Comments from the SRB and City Council Approval Conditions

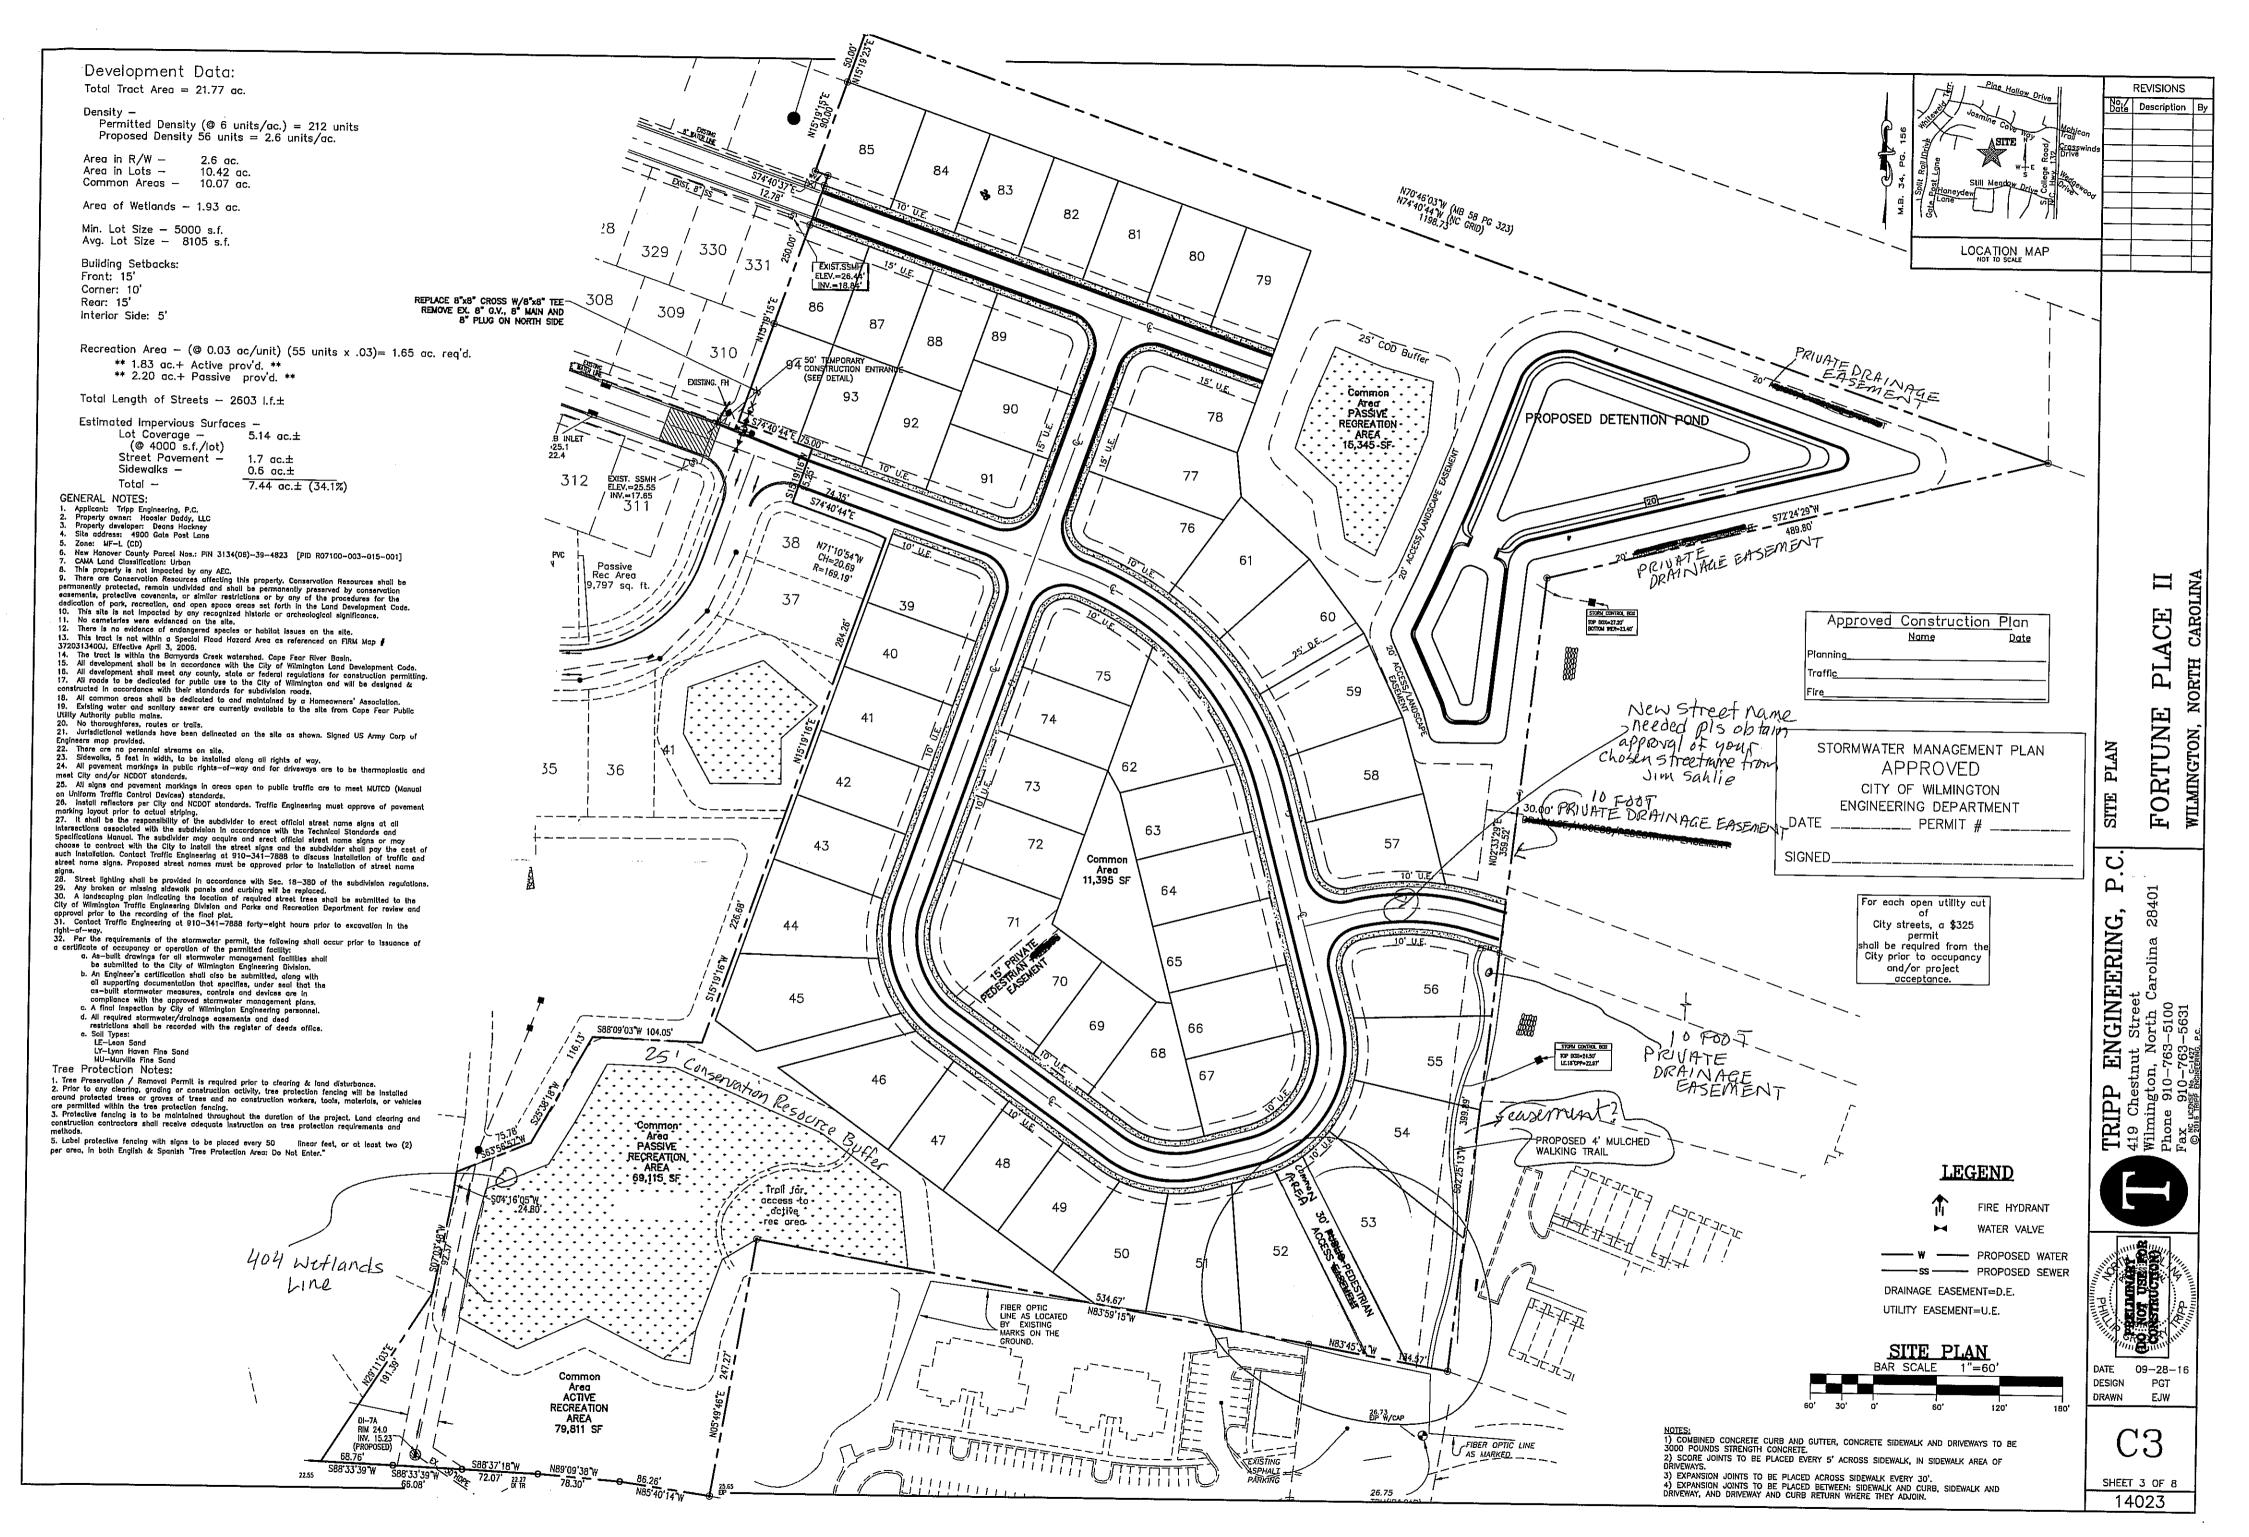
- Please explain the 4-foot walking trail being shown behind Lots 53 56. Yes, a 10-foot private drainage easement is needed however, you can modify the alignment of the proposed trail; once that is done, you may want to reduce the width of the pedestrian easement to fewer than 10 feet while locating it within the drainage easement.

- 2. Explanation is needed regarding the access/trail to the Passive Rec. Area. Common area is being proposed between Lots 45 and 46 and it's assumed that is so residents can reach the Active Rec. Area. Regarding disturbance of the 404 Wetlands area, would it be preferable to keep the trail outside of the 404? It may be a problem as it is being shown because a USACOE disturbance permit may be required.

- 4. After TE shows the markups in the next version of plans submitted to city, surveyor please note same changes on plat.
